This document is a response to the Harmony SP6 Initial Submission Review comments we received on February 3rd, 2023.

Application Number: DA-1925-14

Case Numbers: **2013-7001-07; 2023-6001-00; 2023-4001-00; 2023-3001-00**

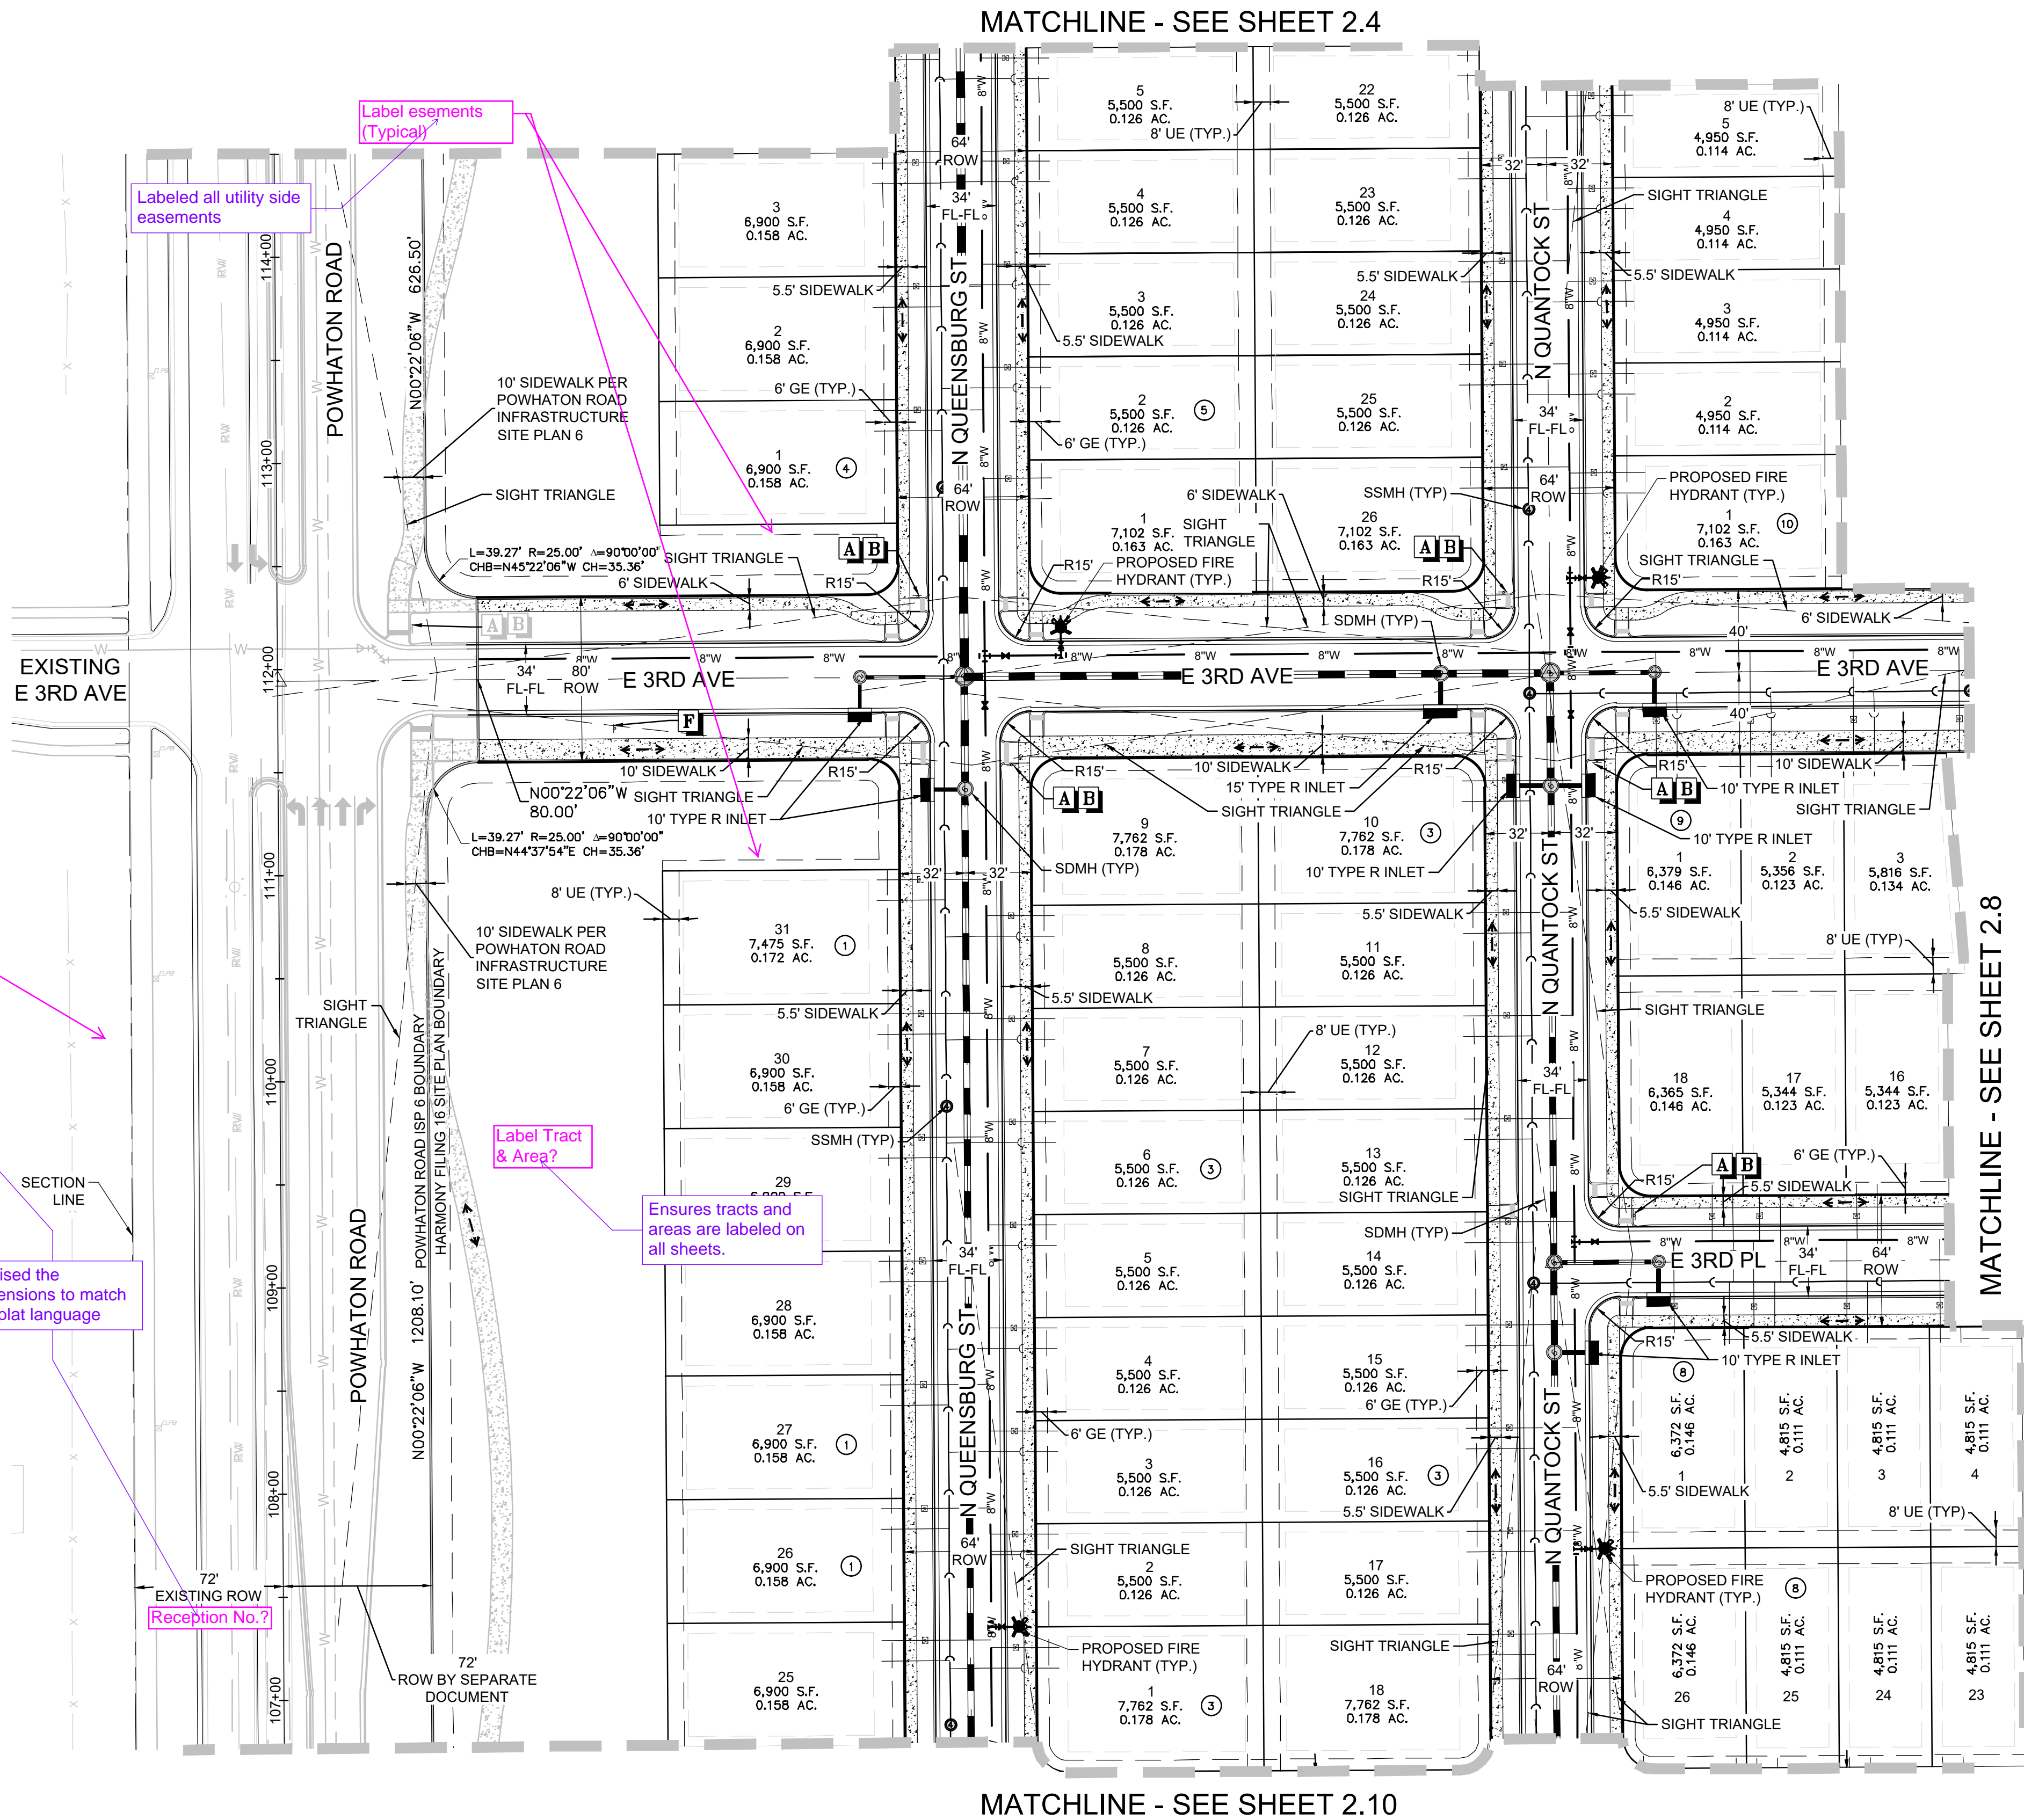
Reception No.?

Revised the dimensions to match the plat language
